BUILDING | HISTORIC PRESERVATION | PLANNING & ZONING

354 SE 5th Avenue

Request

**Review & Analysis: Site Plan and Zoning****LDR Section 2.4.5(F), Class V Site Plan**

Landscape Waiver

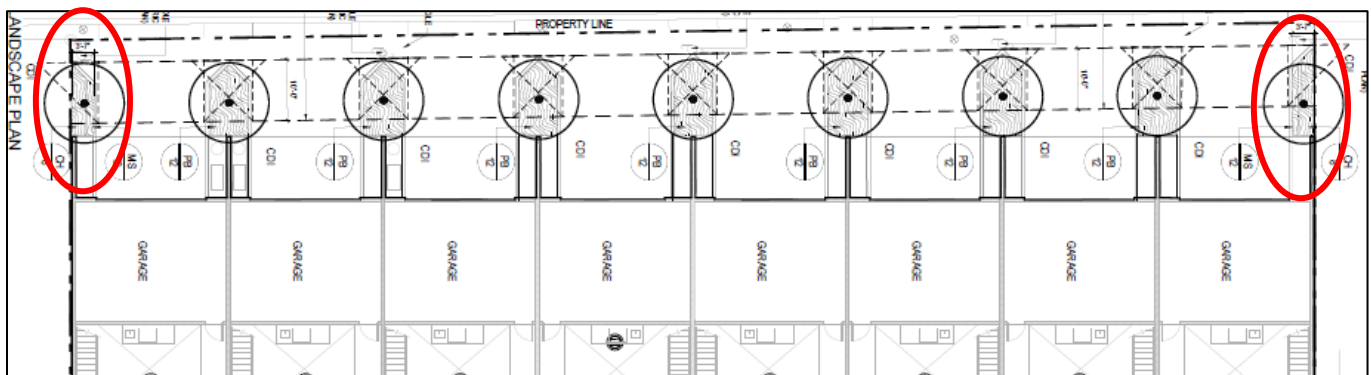
The applicant is proposing a landscaped barrier between the driveways for the end units and the adjacent property lines, as is required, however the width of the landscape area proposed is three feet, seven inches (four feet including curb) rather than the minimum required of five feet. The reduced width, however, is still able to accommodate a shade tree and hedge row of 24 inches in height to provide screening of the vehicular use area from adjacent properties, thereby still meeting the intent of the code to the maximum degree feasible. The landscaped islands between each driveway for each unit provides a width of six feet, four and one half inches (excluding curbing) that accommodates shade trees and other landscaped accents.

In consideration of the criteria, the reduced width along the ends does not have a negative impact on the neighboring area, as the similar amount and/or type of landscaping has been provided. Most importantly, the required shade tree (16 ft Pigeon Plum) has been provided. Public facilities will not be impacted by the reduction, nor will it create an unsafe situation. Similar circumstances would be considered for the same type of request, thereby not resulting in the granting of a special privilege.

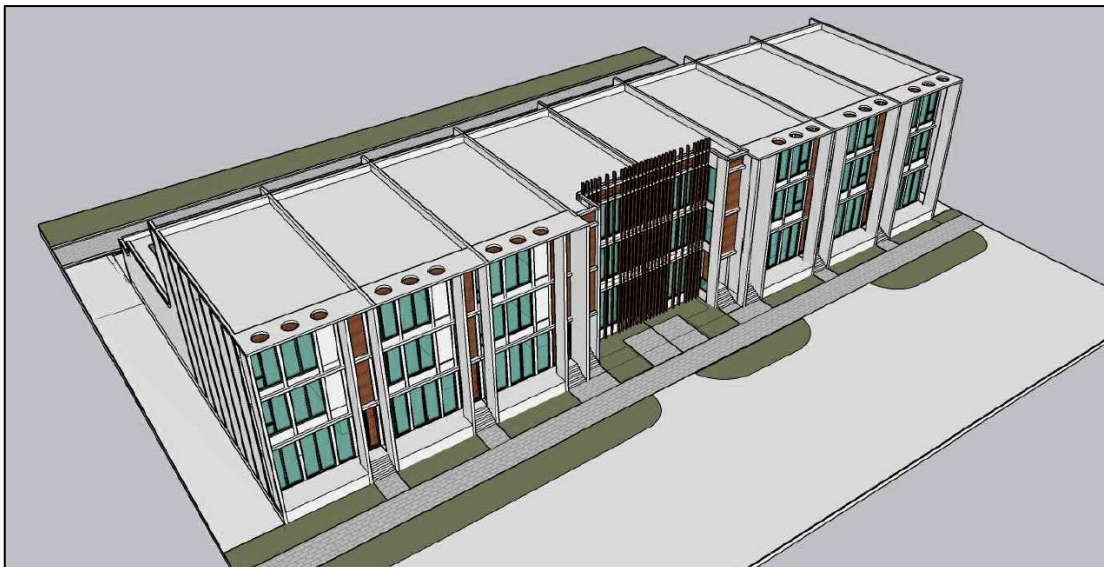
The proposed front elevations provided below have been reviewed for compliance with both Section 4.6.18 and the architectural standards in 4.4.13.

The proposed development is generally in conformity with good taste and good design as it incorporates many elements of the Masonry Modern architectural style outlined in the Delray Beach CBD Architectural Guidelines. The overall design and quality appearance is not anticipated to "materially depreciate" the adjacent properties or other properties in the vicinity. Further, there are no specific design elements identified that are not in keeping with the architectural style or the intent of the Criteria for Board Action.

The proposed design is a unique execution of Masonry Modern that departs from the more commonly proposed versions of the style that are typical and largely generic. As is customary with Masonry Modern, stucco is a prominent material used with teak wood accents that contrasts well with the glass and white stucco. The large break in the building with the forecourt adds an interesting articulation to the building that is not commonly proposed. Nevertheless, the proposal is anticipated to add interest to the SE 5th Avenue corridor, while contributing to the image of the City with the high quality design.
